Index 102-602

Two-Lane, Two-Way, Work on Shoulder

COMMENTARY

COMMENTS AND RESPONSES

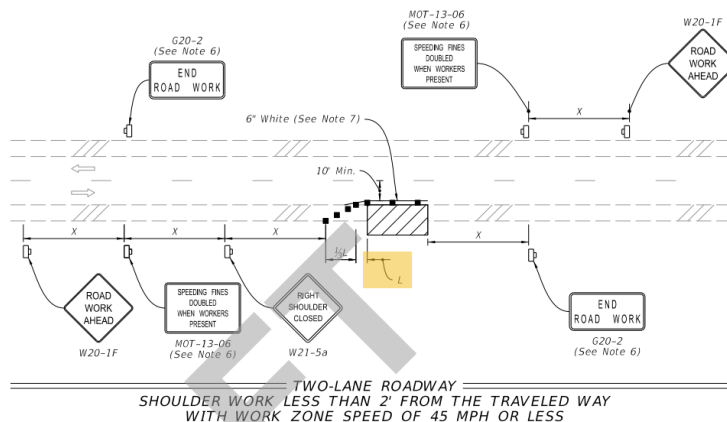
4. Seems to be an errant label of L in the below detail.

RESPONSE: *Agreed, the intent was to provide a buffer space.*

Change Made: *Buffer space (B) added to details.*

SHEET
1 of 2

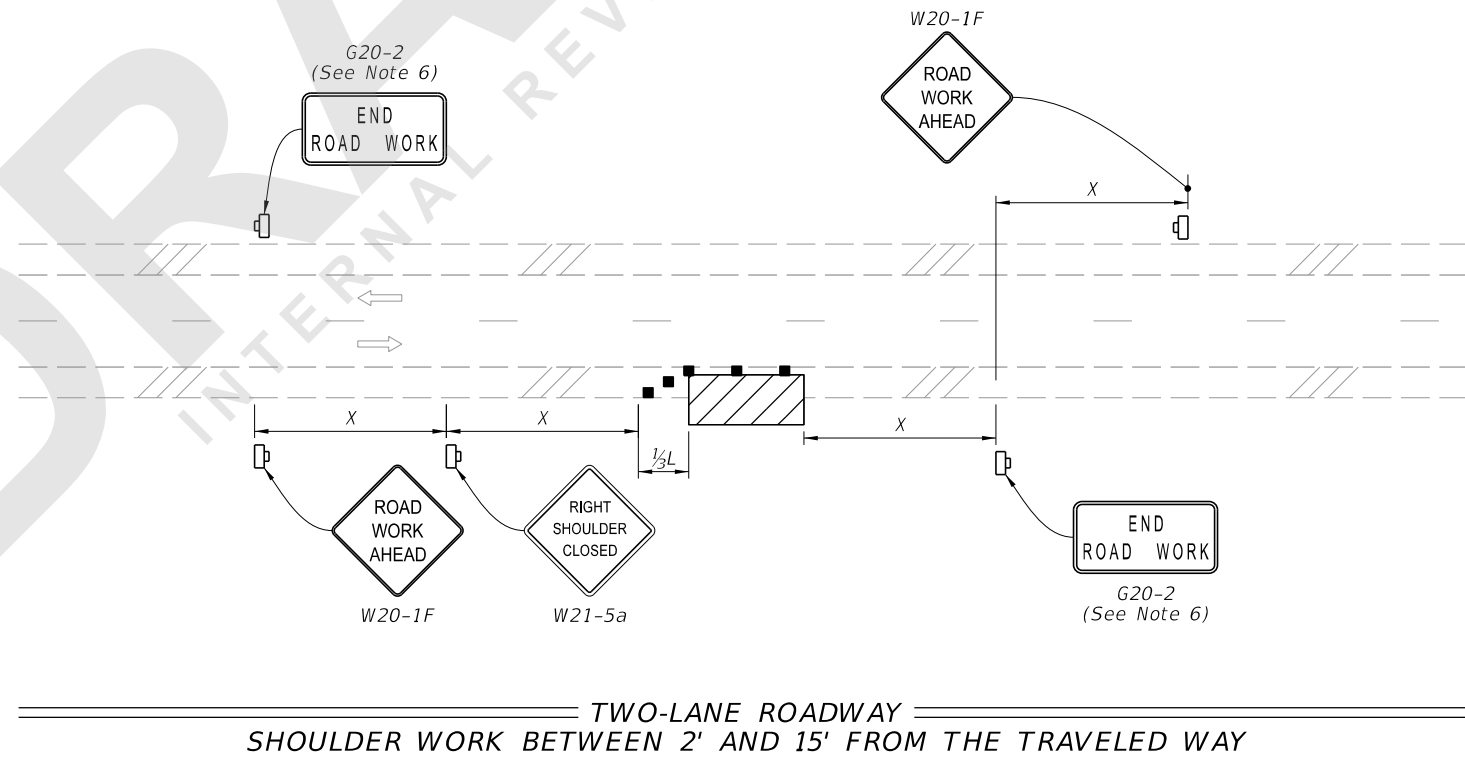
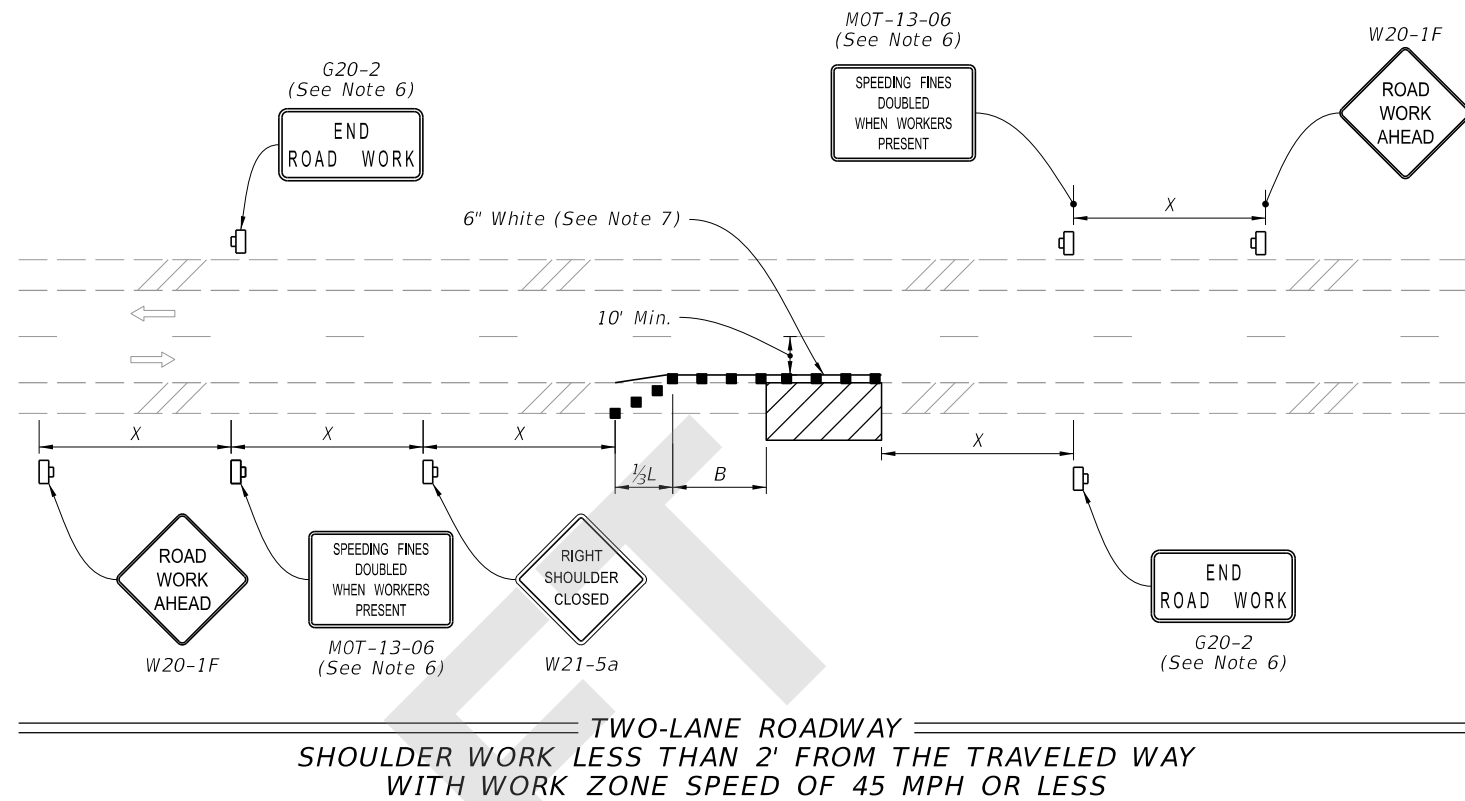
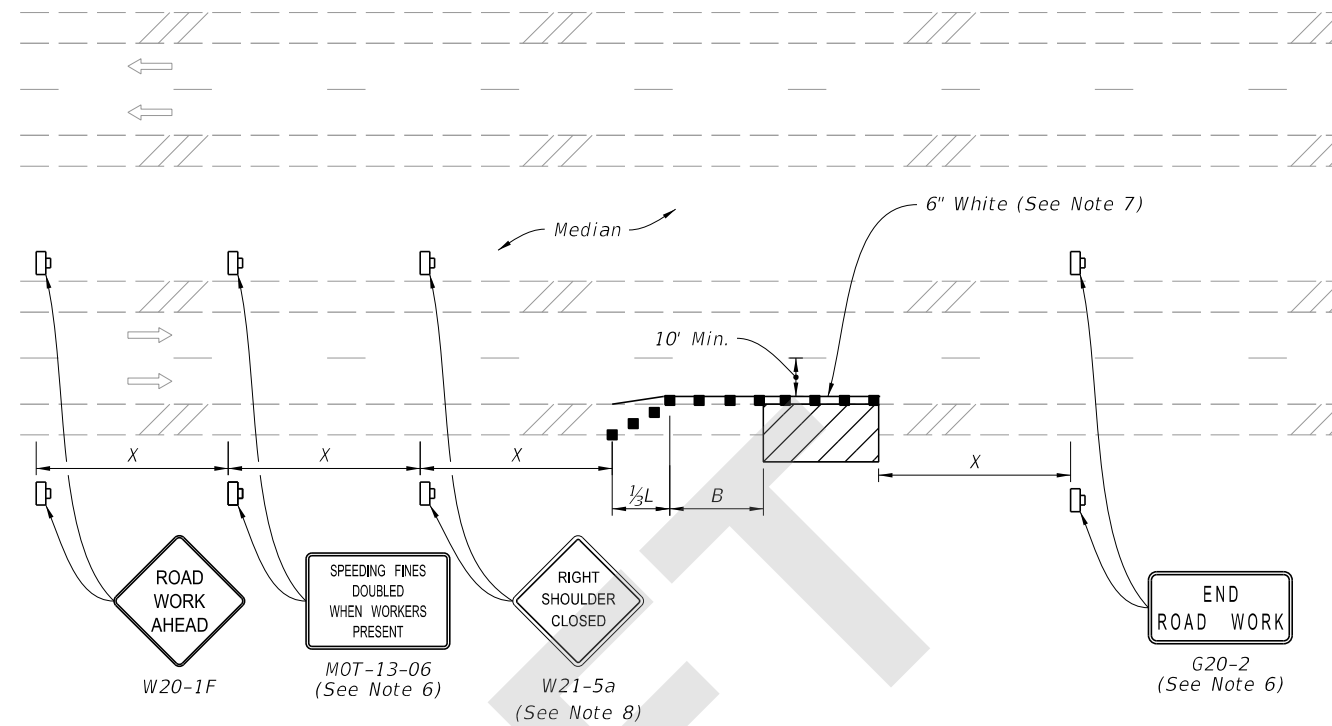
2. 102-602 (1/2): Why note No. 9 indicates to omit "Shoulder Closed" sign when work is at the median? If a shoulder is present and it will be closed.

COMMENT: The white stripe can be eliminated if less than 24 hours per note 7. I'm not sure if this is a new requirement per MUTCD. I don't support placing the white stripe. It will be an eradication issue if painted on older pavement. Resurfacing for this reason is cost prohibitive.

1. Sheet 1 and 2: No detail is provided for shoulder work with greater than 45 mph speed- this work situation occurs in maintenance often.

1. Sheet 1 of 2: what is the intent of Note 8 which refers to the Plans?

RESPONSE: *"Shoulder Closed" signs are optional, per the MUTCD, and not previously required in the Standard Plans. However, it is now being added in an effort to give better advanced notice to bicyclist and pedestrians that the shoulder is closed in the work zone. Typically, bicyclist and pedestrians do not use the median shoulder.*

RESPONSE: *The requirement is in addition to the MUTCD requirements/options (i.e., there is no requirement or guidance to include the stripe). However, the concern is acknowledged and for consistency with other Indexes the option to omit the stripe will be extended to durations of 3 days or less.*

Change Made: *Temporary striping note revised from 24 hrs to 3 days.*

RESPONSE: *Only the "Less Than 2' From Traveled Way" details are limited to ≤ 45 MPH speeds. The "Shoulder Work Between 2' and 15' From The Traveled Way" details can be used at any speeds. See Note #5 for additional information for roadways with work zone speeds > 45 MPH.*

RESPONSE: *Consideration for bicycle accommodations should be shown in the Plans and not left to the Contractor. Therefore, the TTC Plans should address what accommodations are provided (i.e., Use: Index 102-661, project specific details, or Do-Nothing).*

SHEET
2 of 2

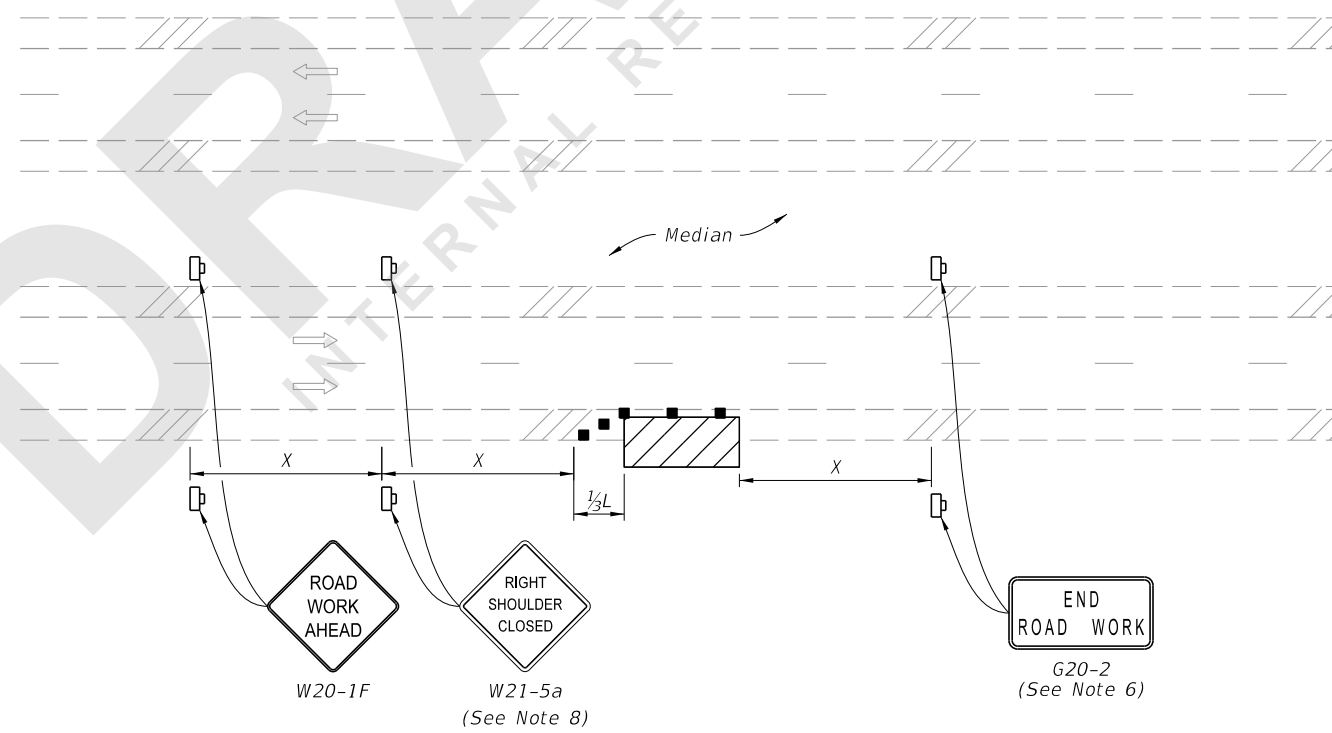
2. Sheet 2: The duration provision has been deleted-this has been used by maintenance.

RESPONSE: *The "Duration" considerations have been revised and are now reflected in the Notes. See Notes #3 and #6. Specification 102 requires all vehicles in the work area to have SAE J595, Class 2 warning lights, regardless of duration or condition. For incidental work only a "Road Work Ahead" would be required.*
